D240002: New Zealand Transport Agency Notice of Requirement SH 1 Rolleston Access Improvements

Request for further information

Figure 2.1 Potential pinch point that may prevent the “Future Reserve Path” proposed by Selwyn District Council as part of its Walking and Cycling Strategy

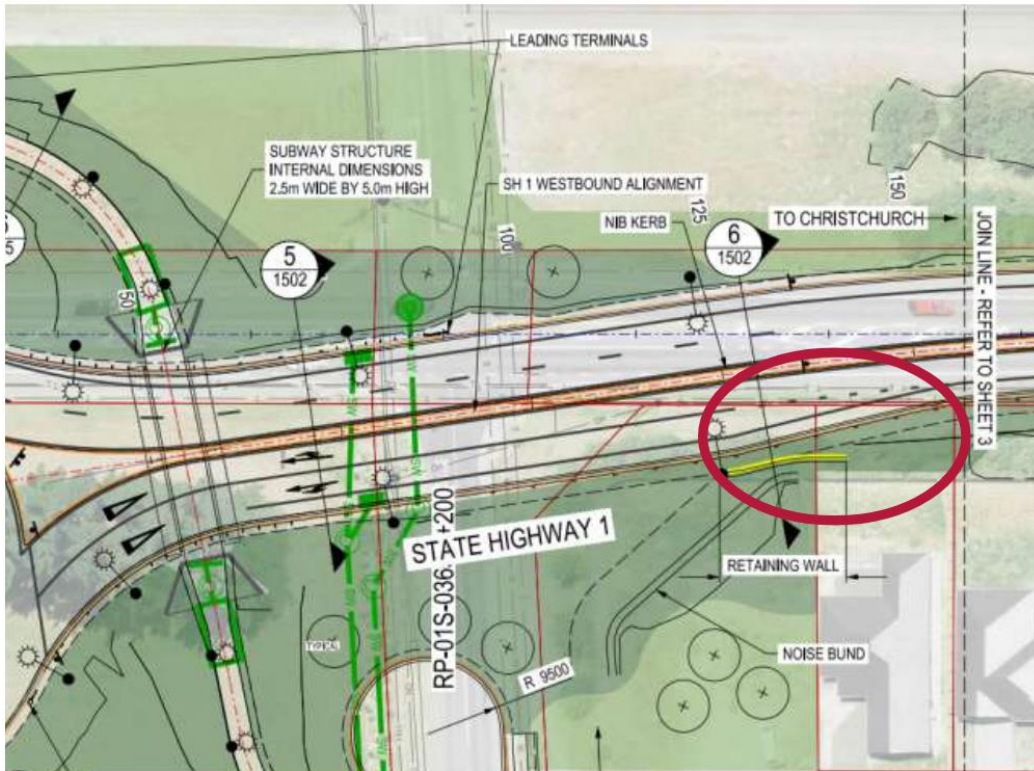
- e) Commentary on whether the pinch point, shown in Figure 2.1, forecloses the opportunity to provide the “Future Reserve Path” proposed by Selwyn District Council as part of its Walking and Cycling Strategy (and shown in Figure 5-10 of the ITA).

Figure 2.2 Narrowed carriageway of Old Dunns Road South

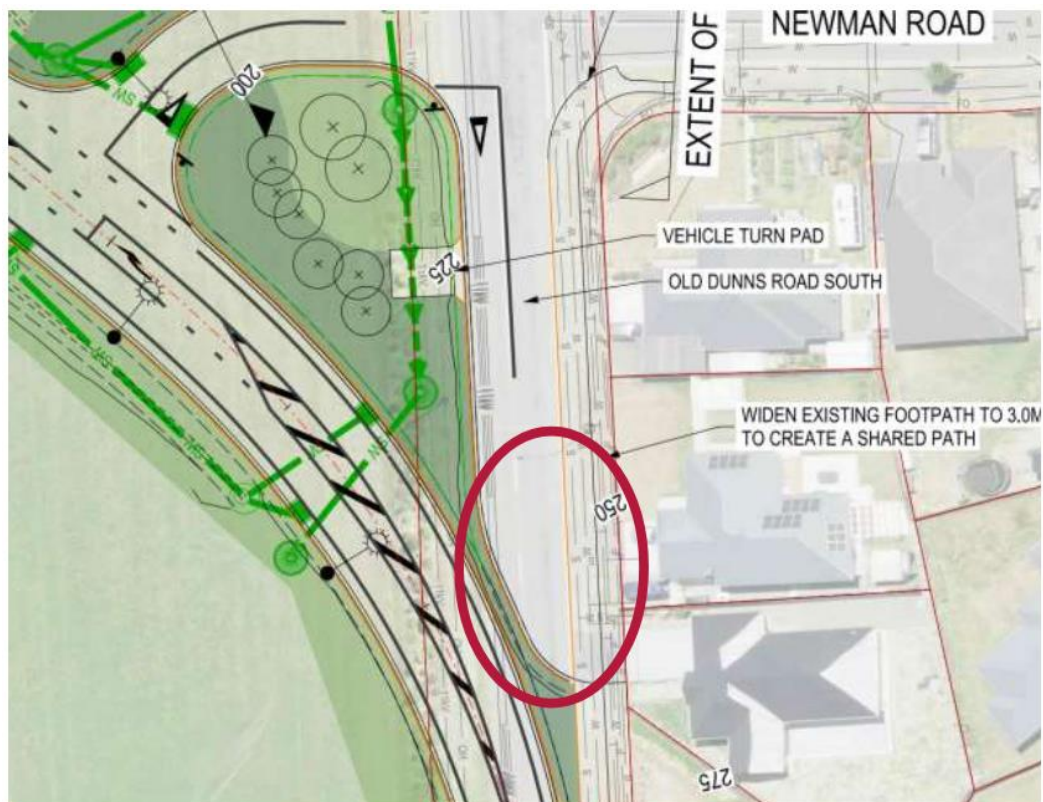
- g) Heavy vehicle tracking for “Old Dunns Road South”, demonstrating whether a waste collection truck can turn around within the new stub road.
 - h) 85th percentile car tracking for 388 Dunns Crossing Road, and confirmation of whether changes to the existing vehicle crossing are required due to the amended kerb line for “Old Dunns Road South”

- i) Commentary on the practicalities of Council having to maintain/replace the carriageway for the southern section of “Old Dunns Road South” in the vicinity of 388 Dunns Crossing Road, shown in Figure 2.2, as the tapering of the carriageway may lead to accumulation of debris and difficulty for laying new carriageway surfacing.

Discipline:	CIVIL ENGINEERING
Drawing No.	3338703-10-CU-3500
Rev.	A

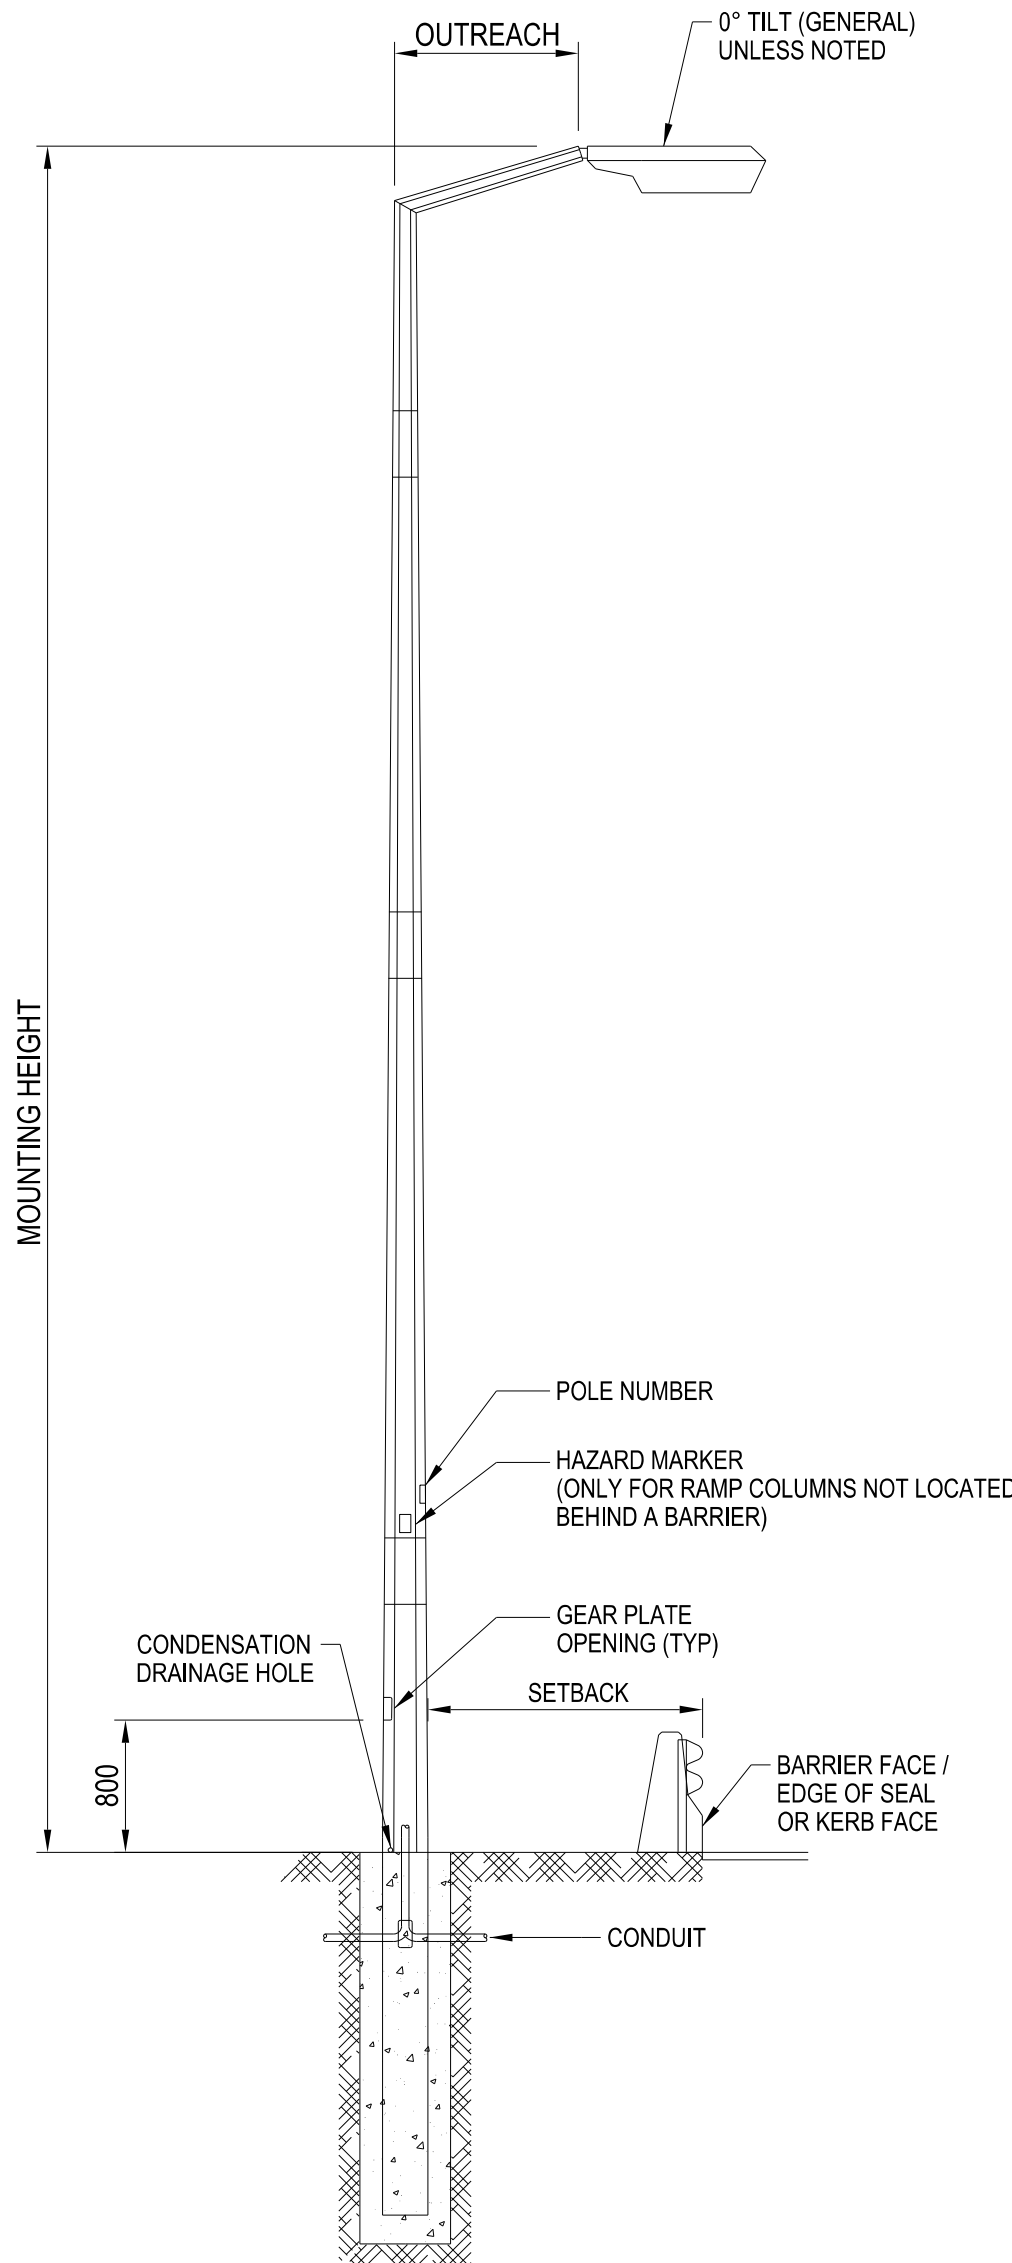
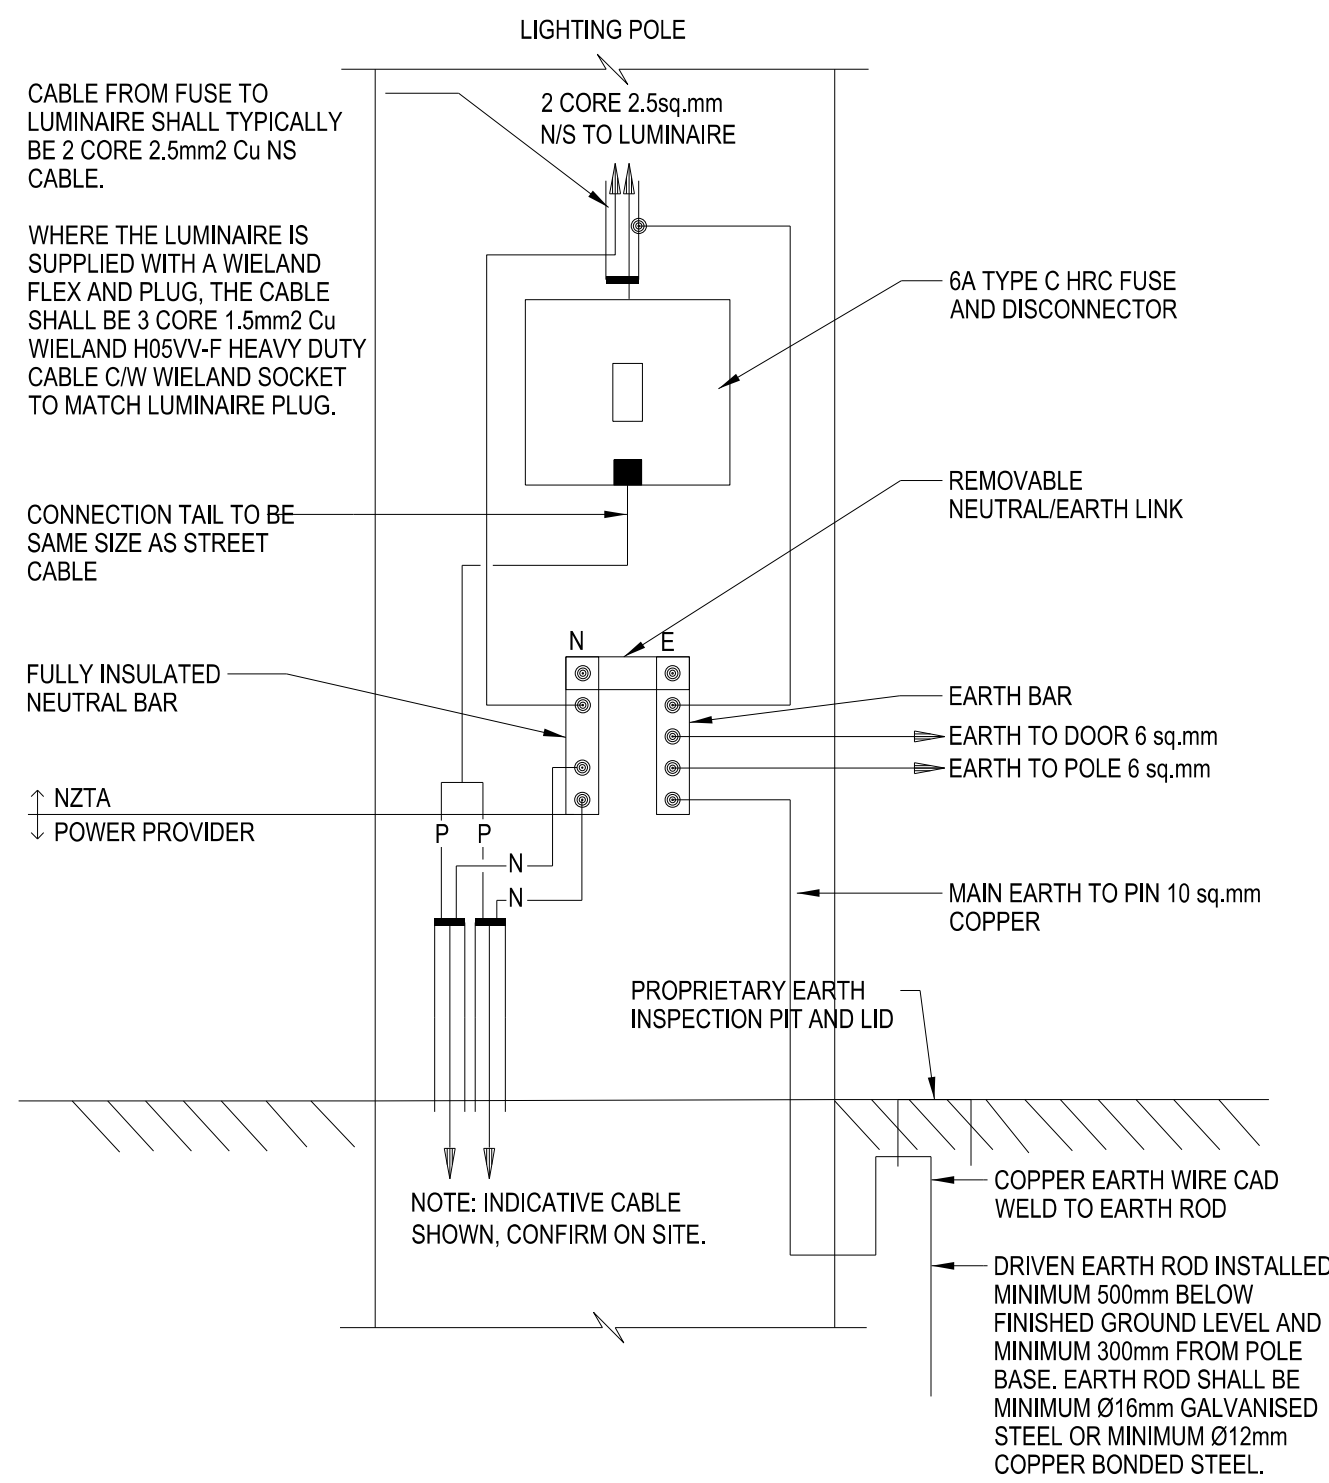
14. Drawing 3338703-10-CU-3500 - Note 6 specifies a shorting cap to be fitted to each luminaire, however NZTA M30 (NZTA Specification and Guidelines for Road Lighting Design) requires that a Central Management System (CMS) system is considered. The use of a shorting cap will require the power supply to be controlled by the local electricity company where they will switch the luminaires on and off remotely by whatever system they employ. Whereas a CMS system will require a Light Point Controller (LPC) to be installed on each luminaire where the switching and dimming is controlled via the CMS system. *Please get the lighting designer to confirm that NZTA is happy with the use of shorting caps on each new luminaire.*

Title: LIGHTING CALCULATION PLANS SHEET 1 OF 5

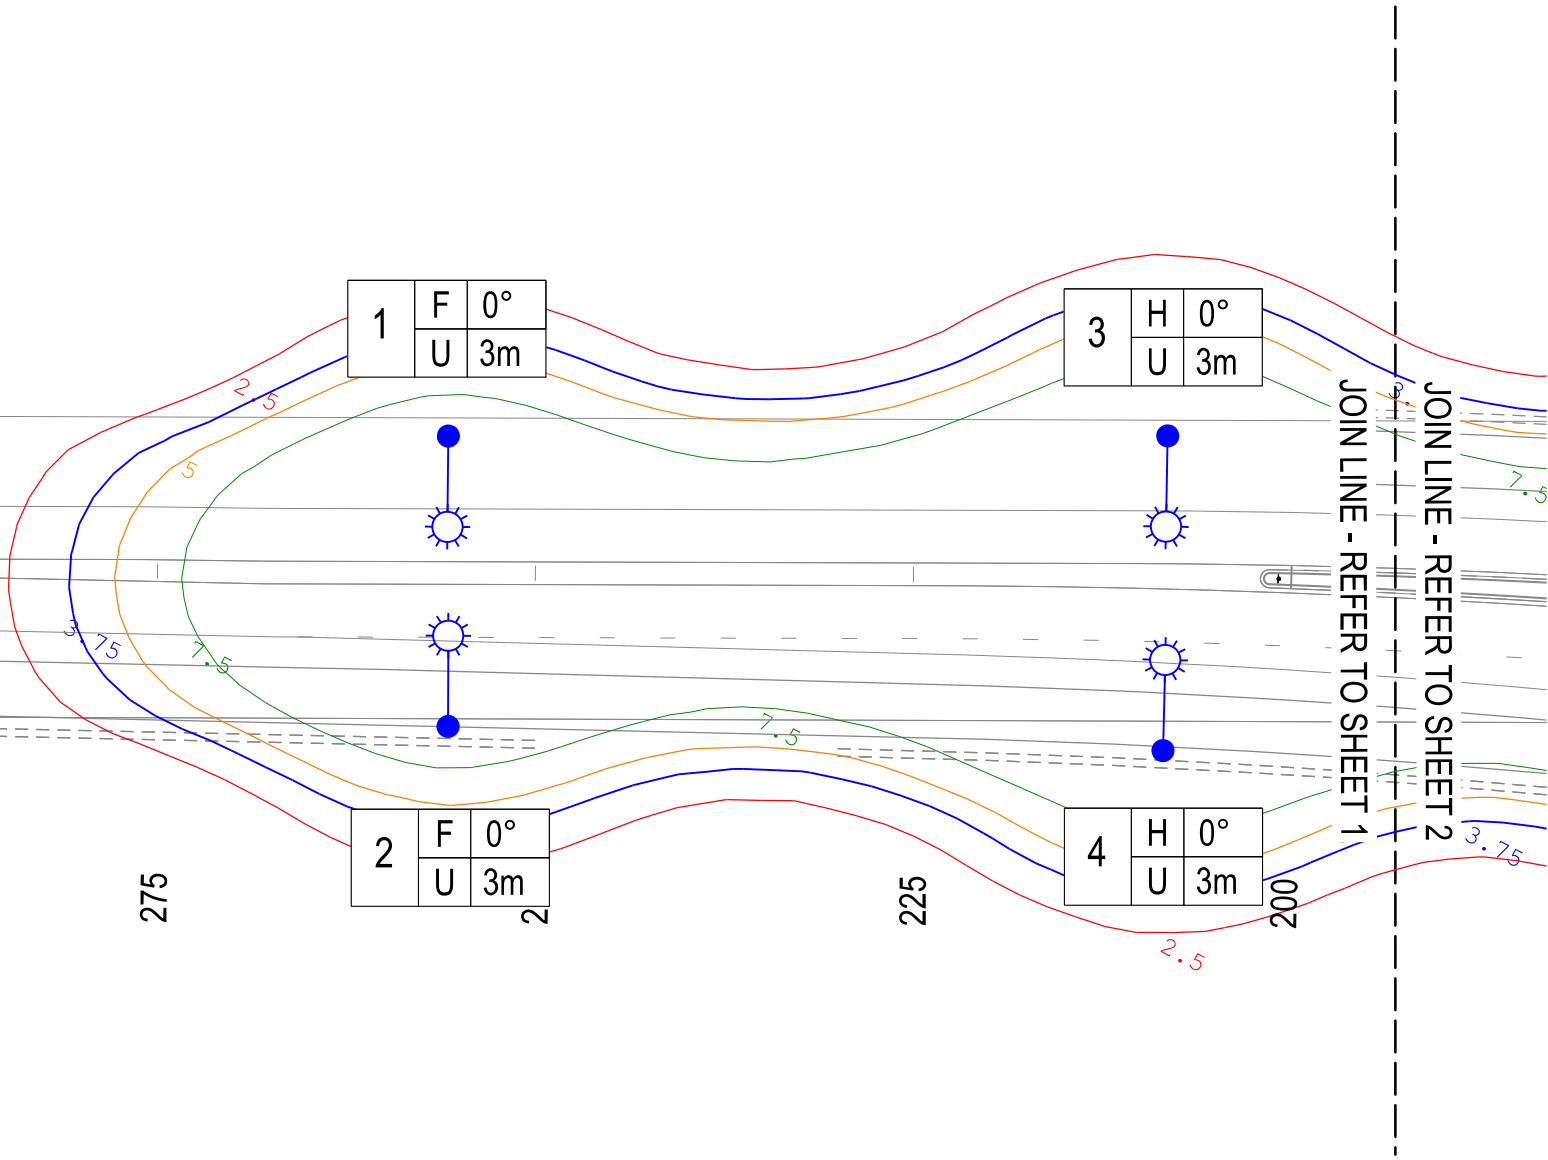
15. Drawing 3338703-10-CU-3521 - Table 3.1 column 5 presents a TI requirement of 9.81%, however this appears to be a typo as the standard requires a maximum TI of 15%. Table 3.1 column 9 presents an UWLR requirement of 3%, however this appears to be a typo as the standard requires a maximum TI of 1% for LED luminaires and 3% for HID luminaires, and as this job involves new luminaires 1% should be the applicable value. *The above comments have been noted as possible typos (to the lighting designer) as information only and are not non-compliances as the calculated TI is 5.53% and UWLR is 0% which are well within the permissible limits.*

16. The TI and UWLR comments in Note 2 (above) are also applicable to drawings 3522, 3523 and 3524.
17. Drawing 3338703-10-CU-3521 - Luminance Calculation Summary table presents one calculation result, but what lane configuration does this calculation apply to? SH1 on either side of the RAB changes from a 4-lane divided carriageway to a 2-lane divided carriageway. The luminaire arrangement also changes from an opposite arrangement to a single sided arrangement at the eastern end SH1. There needs to be multiple luminance calculations to account for the different lane configurations and luminaire arrangements. *Please get the lighting designer to confirm that the luminance calculations apply to all of the lane configurations (4-lane and 2-lane divided carriageways) and luminaire arrangements (SS and Opp) or supply additional calculation results to cover all arrangements.*

What lane configuration does this calculation apply to?
SH1 on either side of the RAB changes from 2-lane (either side of a raised median) down to single lane on each side of the median. There needs to be 2 calculation for each lane configuration.
